Building Code of Australia 2019

Report for BCA Compliance

PROJECT NAME: New Western Sydney University Bankstown City Campus

DATE: 24th August 2020

Clause C1.9 – Non-combustible Building elements

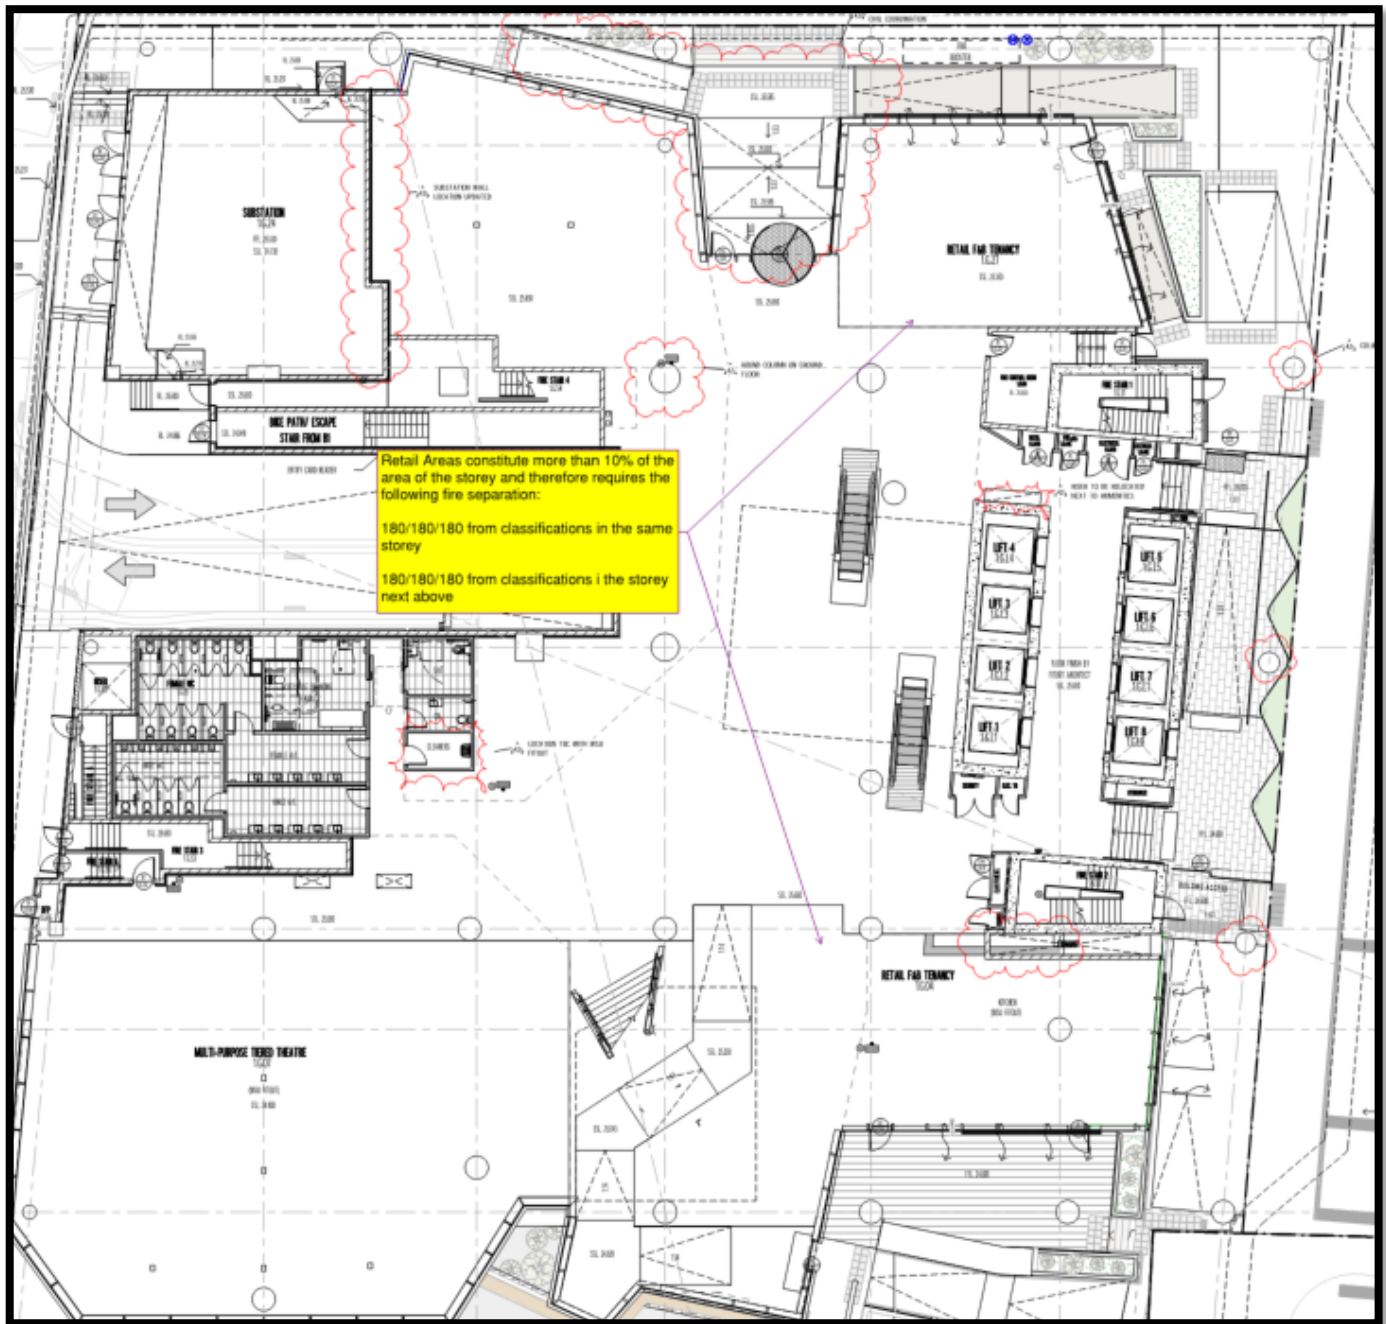
In accordance with Clause C1.9, the following building elements are required to be non-combustible

- External walls including all elements incorporated within them including façade covering, framing & insulation; and
- Flooring & floor framing of the lift pit (if applicable)
- Lift Shaft
- Non-loadbearing internal walls that are required to be fire-resisting (i.e. SOU bounding walls)

Provide a schedule of materials proposed to be used in the construction of any of the abovementioned elements to allow assessment of combustibility.

Clause C3.2/3.4 Protection of openings in external walls

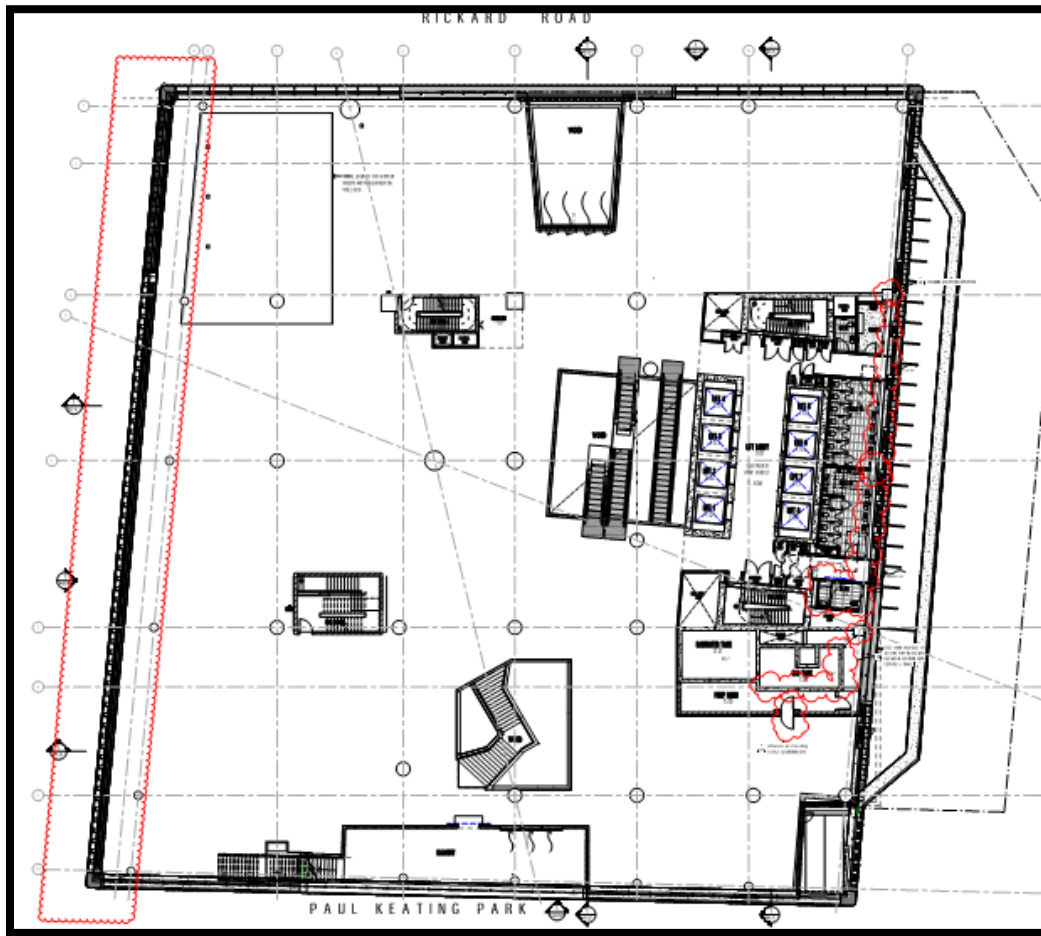
The laneway adjacent to the western side of the building is a non-gazetted road and therefore the site boundary with the laneway is considered a fire-source feature for the purposes of section C of the BCA. Accordingly, the openings in the external wall to levels ground, 1 & 2 at the western façade adjoining the laneway are within 3m of the title boundary and require protection in accordance with this clause.

It is understood that a Fire Engineered Performance Solution will be developed to partially omit the requirement for external wall-wetting sprinklers to this elevation.

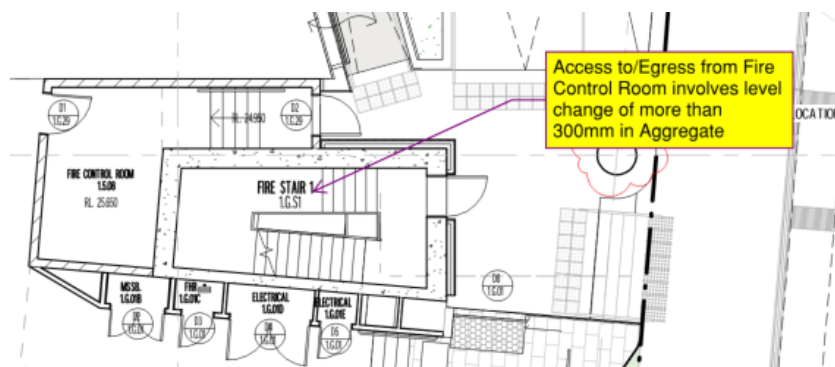
Specification E1.8 requires a Fire Control Centre be located within a separate room (Fire Control Room) where the effective height of a building exceeds 50m. Specification E1.8 (3) states that a fire control centre must not be so located in a building that egress from any part of its floor, to a road or open space, does not involve changes in level which in aggregate exceed 300mm.

The proposed location of the fire control room is in aggregate approximately 700mm above the level of the closest area considered a road or open space. It is understood a performance solution will be developed by the fire safety engineer to address this non-compliance.

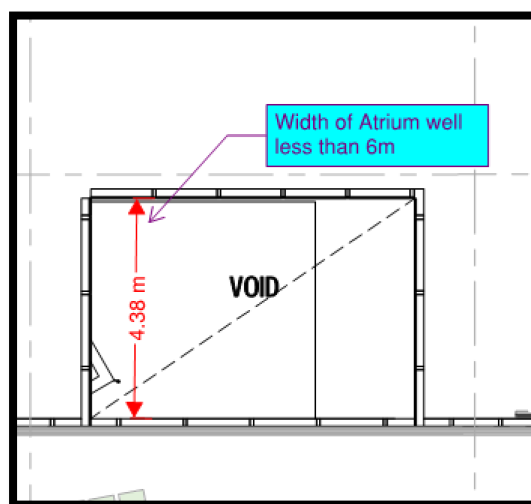
The smoke exhaust rate for the smoke exhaust system required for the atrium is designed exclusively for Class 9b use however the atrium fire compartment has Class 6 areas opening into it as well. The exhaust rate is proposed to be 45m³/s in lieu of 74m³/s.

This non-compliance will be addressed via a performance solution developed by the Fire Safety Engineer.

Atrium Bounding Construction

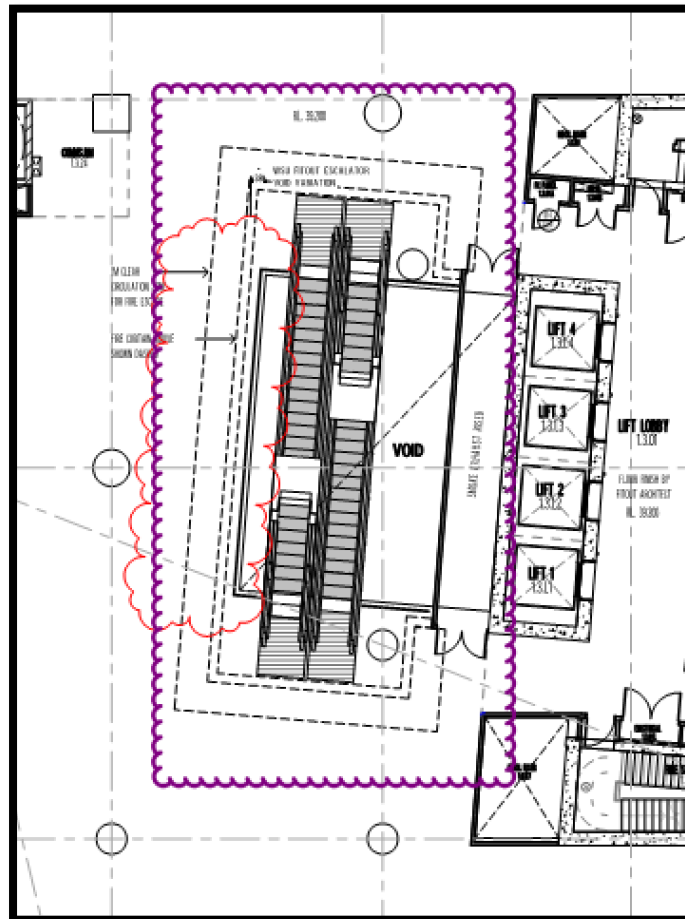
The proposed atrium bounding construction will not strictly comply with the DtS requirements of the BCA as fire curtains are proposed on various levels in lieu of DtS compliant drencher protected glazing or solid construction achieving the required FRL. This non-compliance will be addressed via performance solution developed by the Fire Safety Engineer.
